SUNSHINE COAST REGIONAL DISTRICT

Question and Answers #2

Request for Proposal No. 2437008

Geotechnical Assessment – Slope Stability Chapman Transmission Intake Line

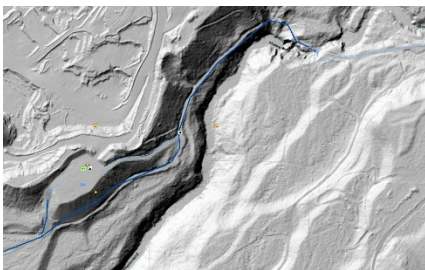
Question: Can you please verity if the blue pins indicate the centre of the watermain or are they offset?

Answer: Unknown, the Regional District will provide a shape file for the infrastructure and surveyed right of way

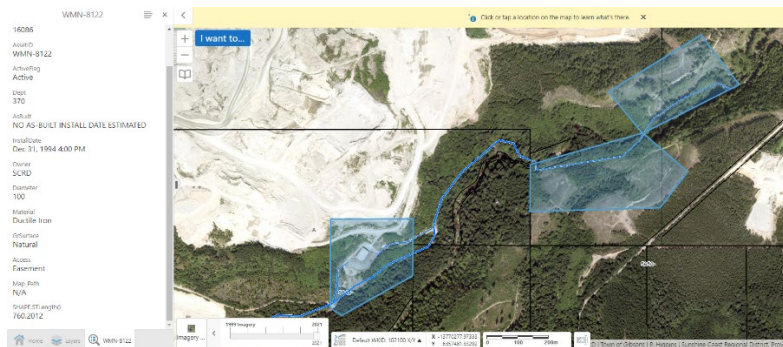
Question: Would the Regional District desire an expansion of the proposed geotechnical assessment area as an additional optional scope to cover the entirety of their water utility assets within the Chapman Creek Ravine? This may include areas such as the slope adjacent to the water treatment plant and the slopes surrounding the 100 mm diameter watermain northeast of the creek crossing at Chapman Falls (see approximate polygons in screenshot below).

Answer: The Regional District would be interesting in knowing and understanding the remainder of the site, the Proponent would need to propose separate pricing and statement of work as part of the request.
